State of California – Natural Resources Agency  
DEPARTMENT OF FISH AND WILDLIFE  
Inland Deserts Region  
3602 Inland Empire Boulevard, Suite C-220  
Ontario, CA 91764  
[www.wildlife.ca.gov](http://www.wildlife.ca.gov)

October 10, 2024  
*Sent via email*

**Comments on the Notice of Determination for an Addendum to the 1991 Environmental Impact Report: Water from the Owens Valley to Supply the Second Los Angeles Aqueduct 1970 to 1990, 1990 Onward, Pursuant to a Long-Term Groundwater Management Plan for Replacement of Wells W247 and W379 (Project), SCH# 1989080705, and Notice of Exemption**

Exhibit 2

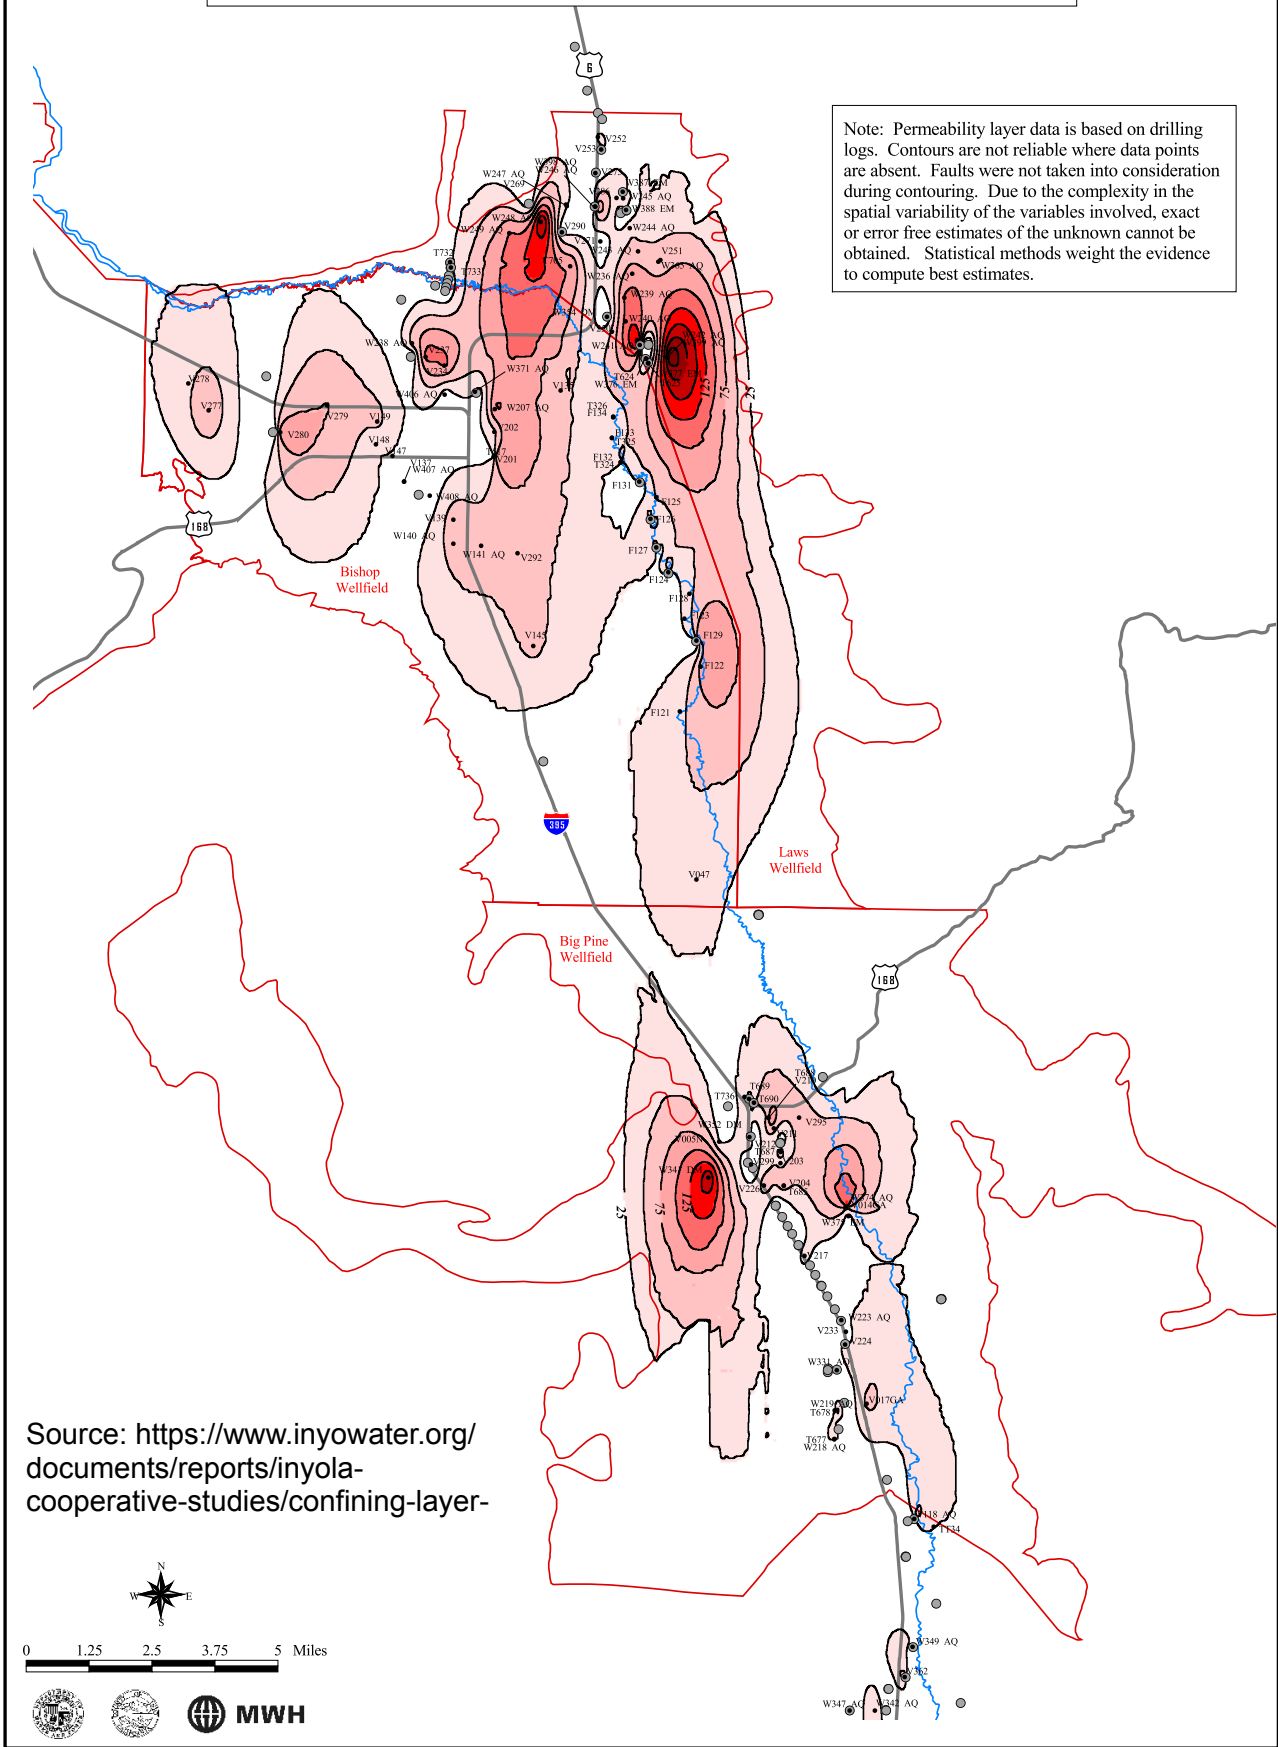
Additionally, the groundwater pumping models for areas surrounding these two new wells do not appear to account for the known extent of the low permeability layers in Owens Valley, as reported by MWH in 2003 (MWH, 2003). Exhibit 2 is Map No. 7 from the 2003 MWH report showing maximum low permeability layer thickness contours for the Northern Owens Valley. While these contours are based on drilling logs, there is uncertainty where logs are absent. The map indicates that the assumption of a continuous semi-confining layer across the Laws and Big Pine Wellfields may not be warranted. Attached are Exhibits 3A, 3B and 3C which are maps of the Laws Wellfield taken from the well W247R Pre-Construction Evaluation Report with the approximate outer boundary of the maximum low permeability layer overlain. Exhibits 4A, 4B, and 4C are similar maps of the Big Pine

CDFW recommends that additional hydrogeologic analysis be done at each of the new well sites and the results of that analysis be provided in a technical report that shows the subsurface characteristics of the aquifer and semi-confining layering Laws and Big Pine Wellfields, including the thickness and lateral extent of the layers, the hydraulic conductivity, and storativity of the layers. It would be important to provide copies of the hydrogeologic data used to identify the sources and areas of recharge to the shallow, intermediate, and deep aquifer systems, as well as identify the existing and/or additional

Exhibit 4A

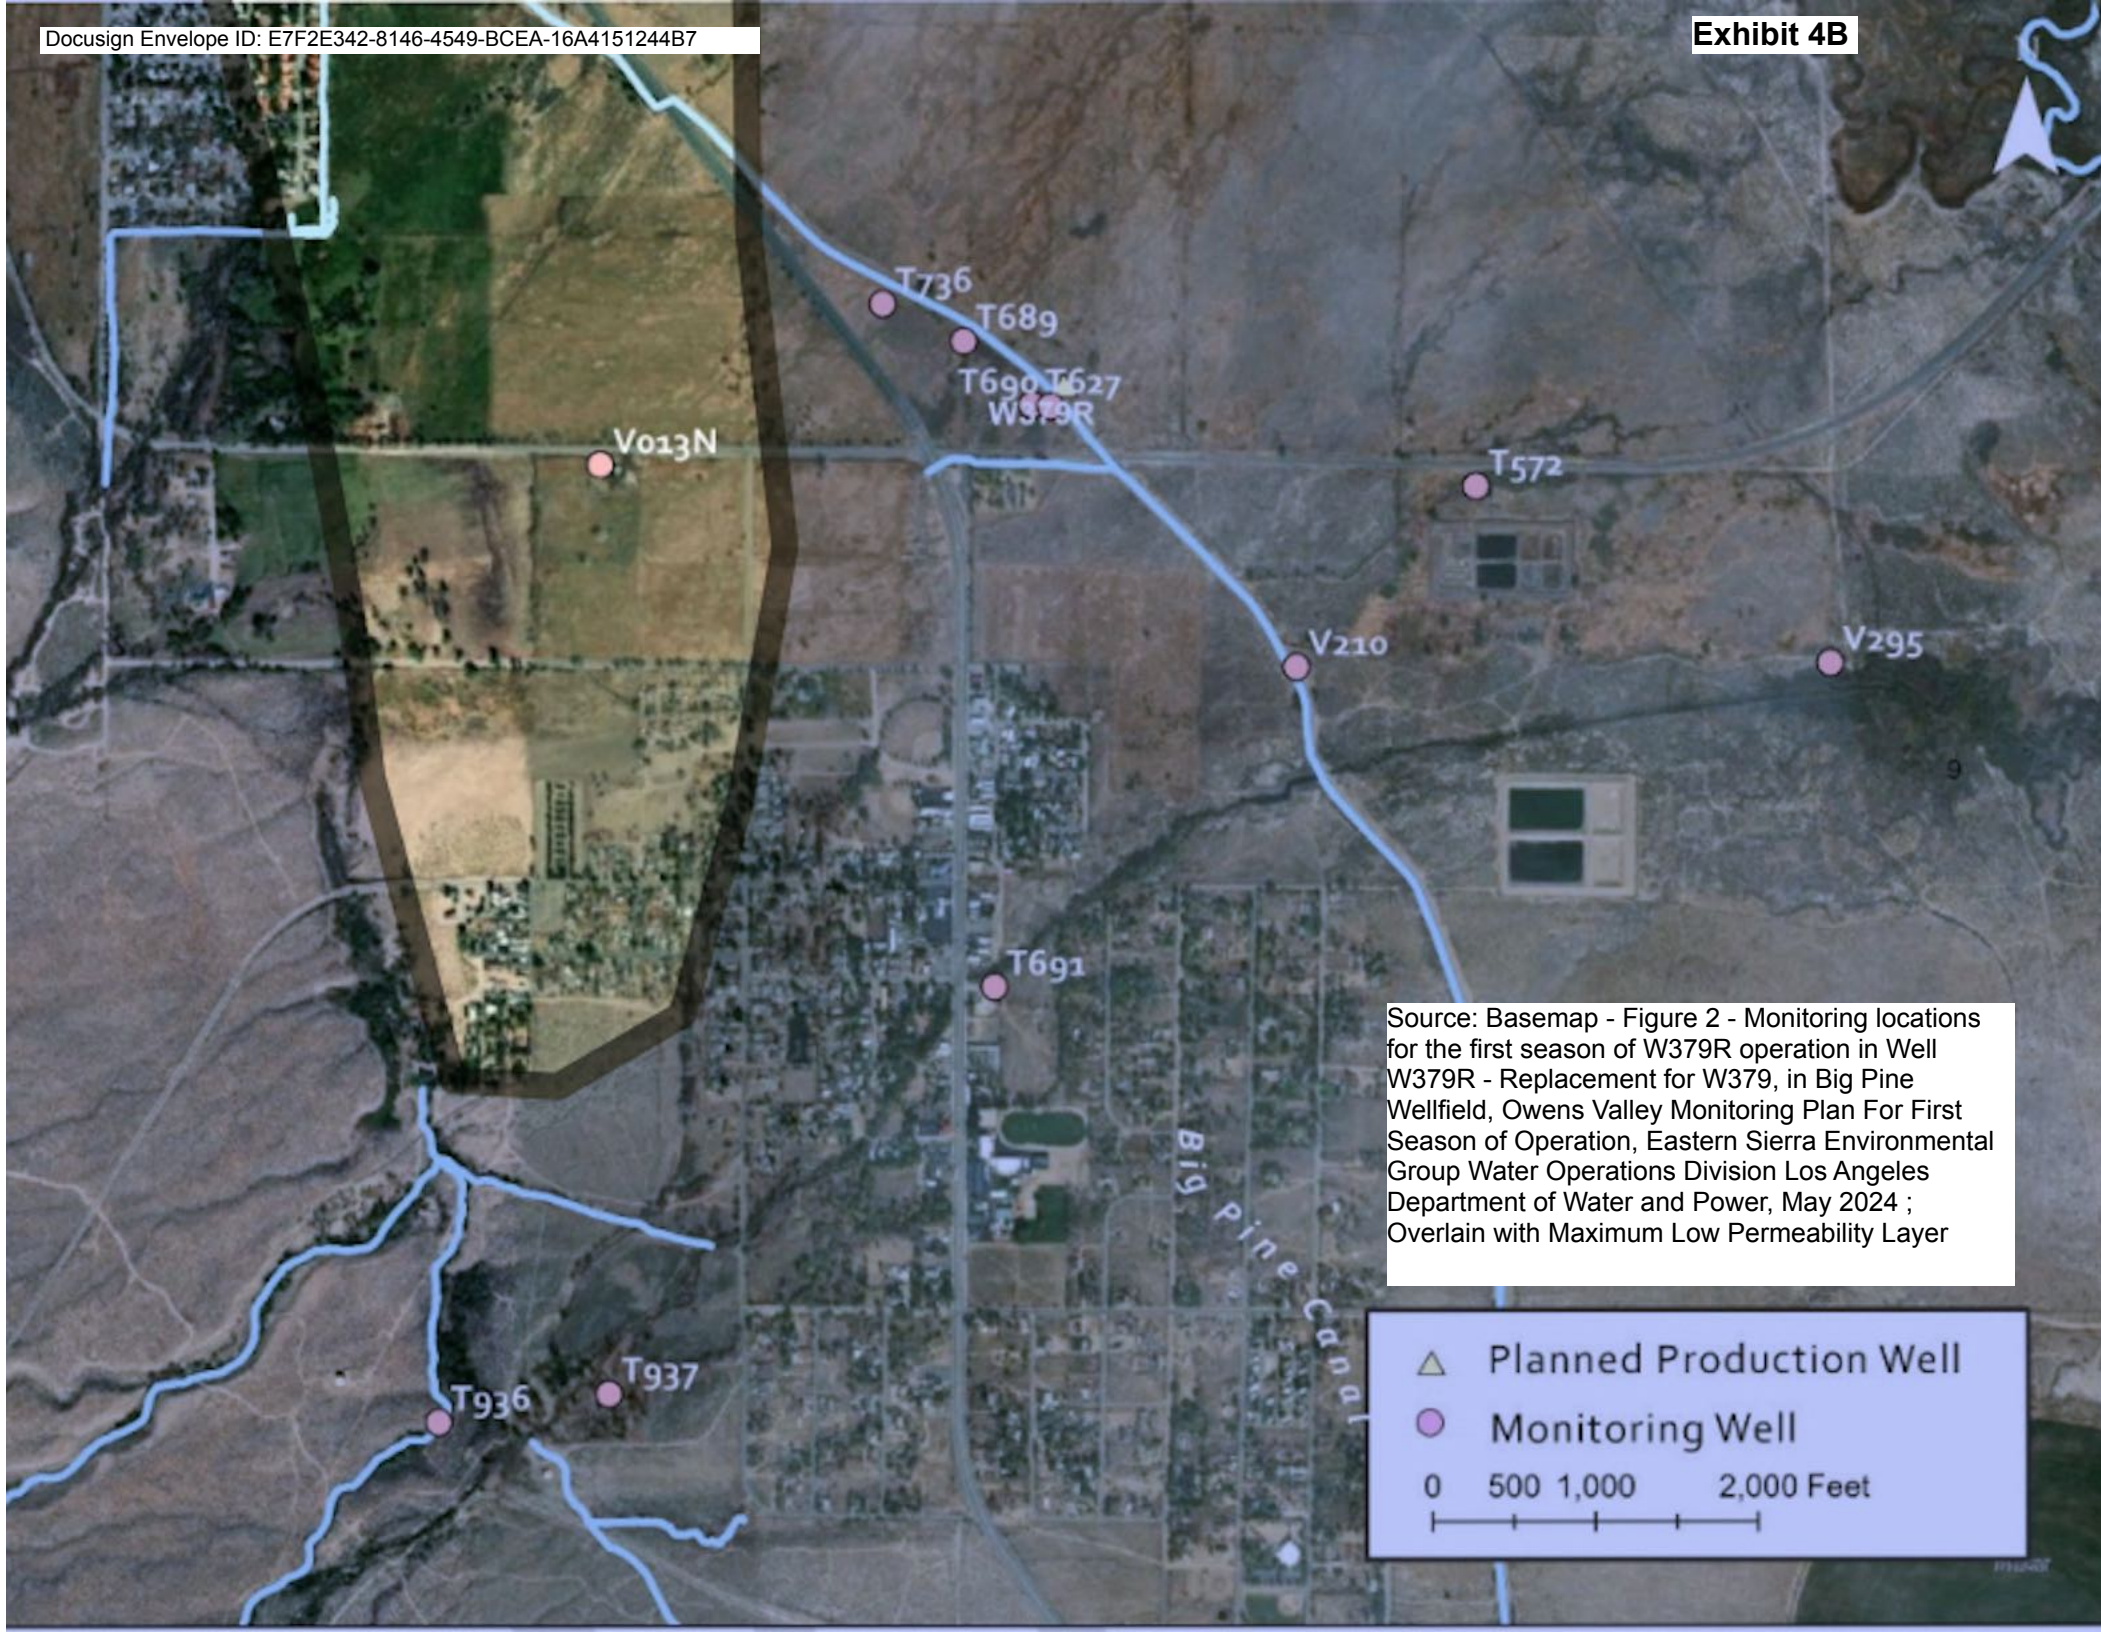
Wellfield. These exhibits show that around the proposed new wells, the known extent of the low permeability layer is not continuous across the model domain.

## Exhibit 4C

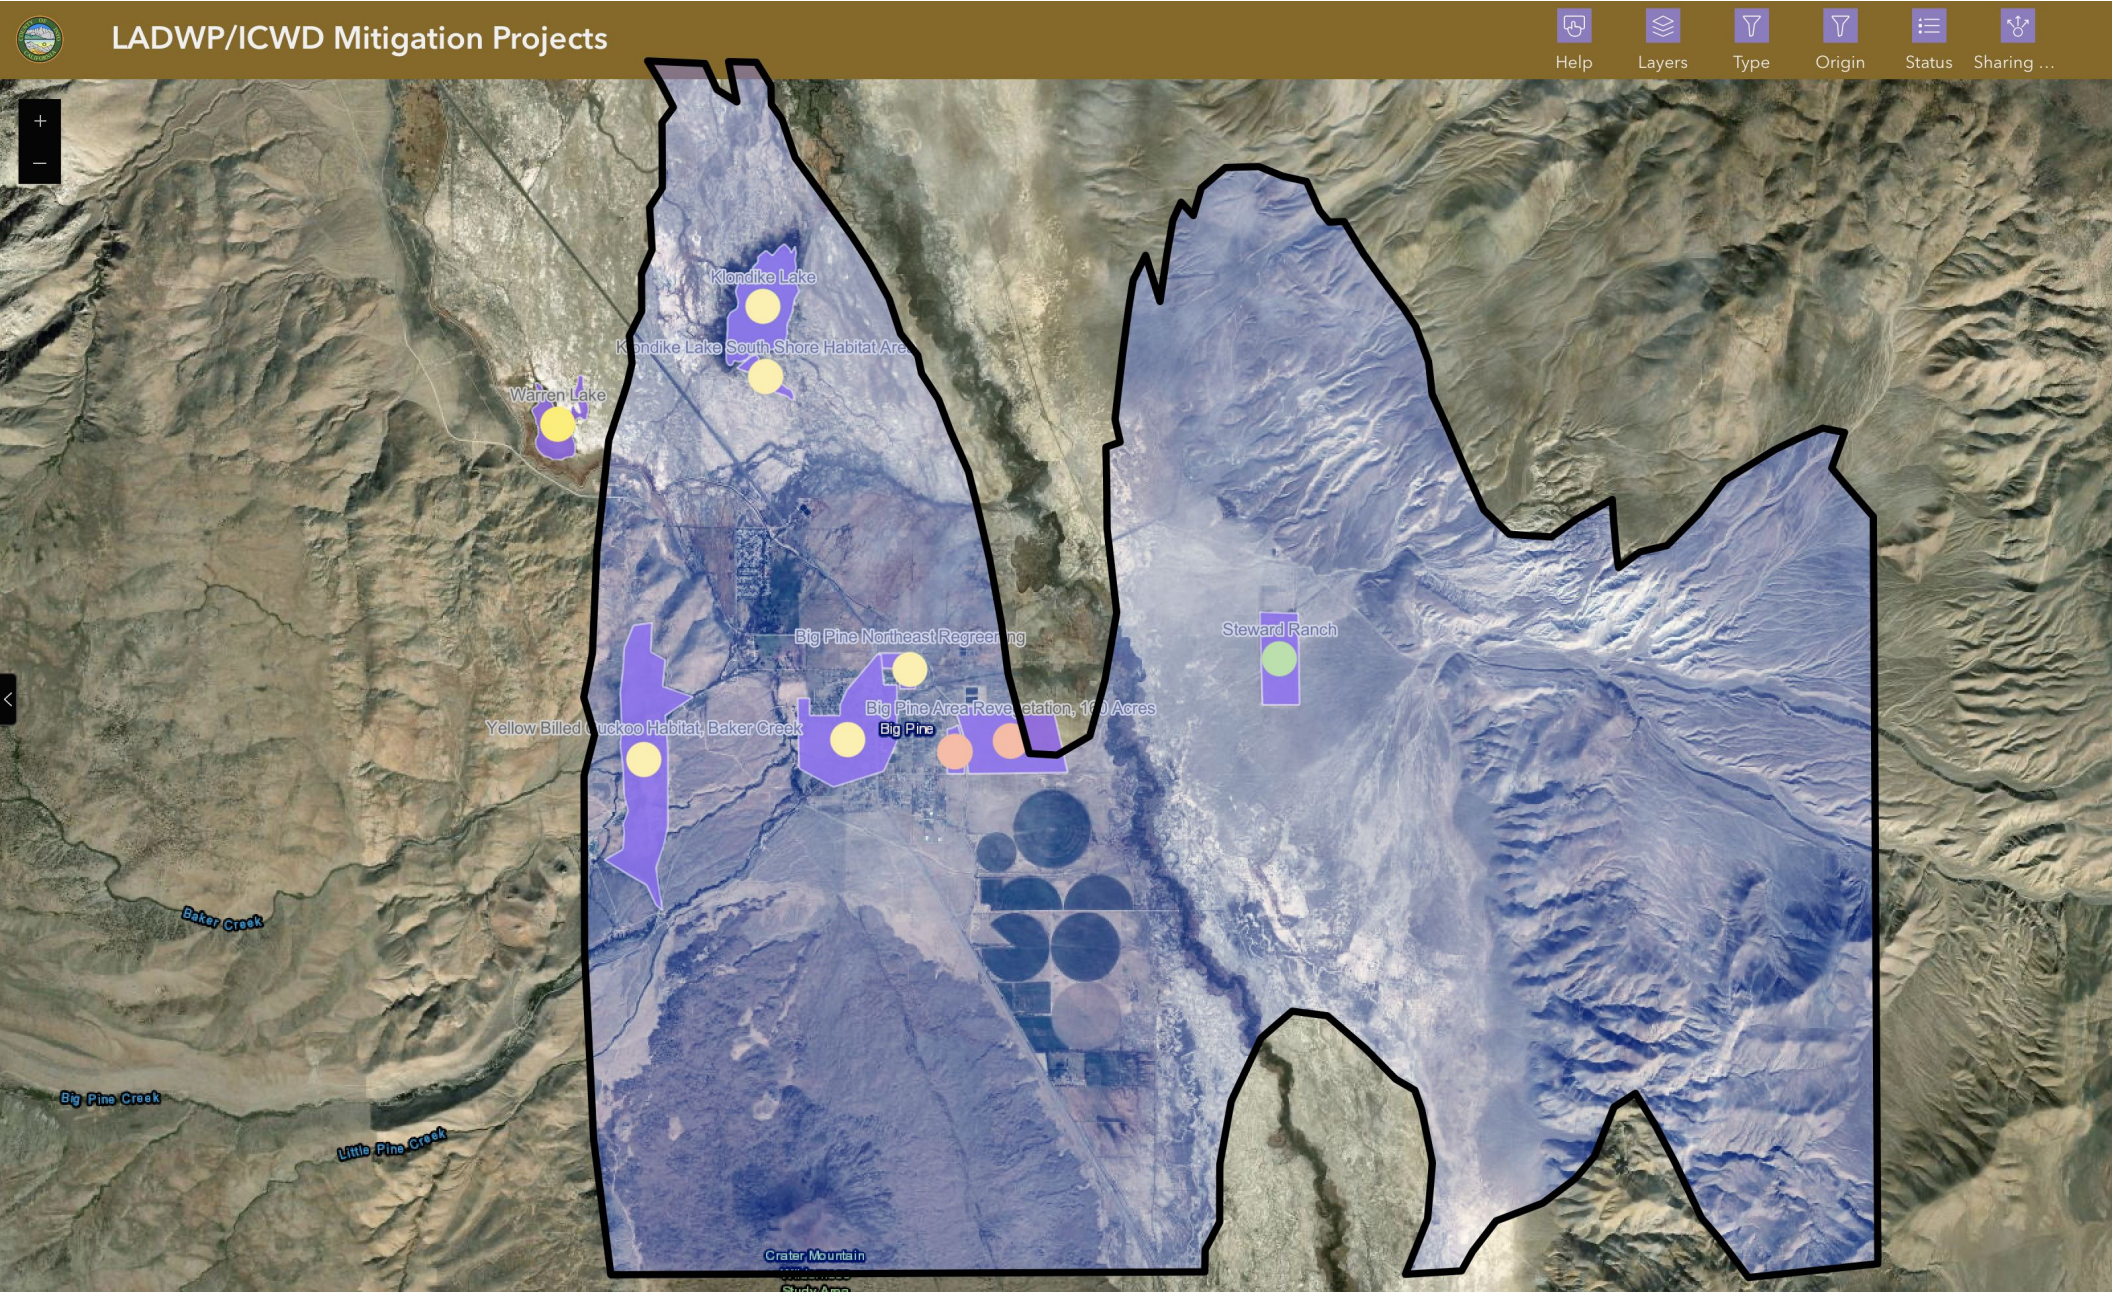
the potential environmental impacts from pumping these wells on surrounding vegetation and habitats and revegetation areas, Exhibits 3B and 4C.
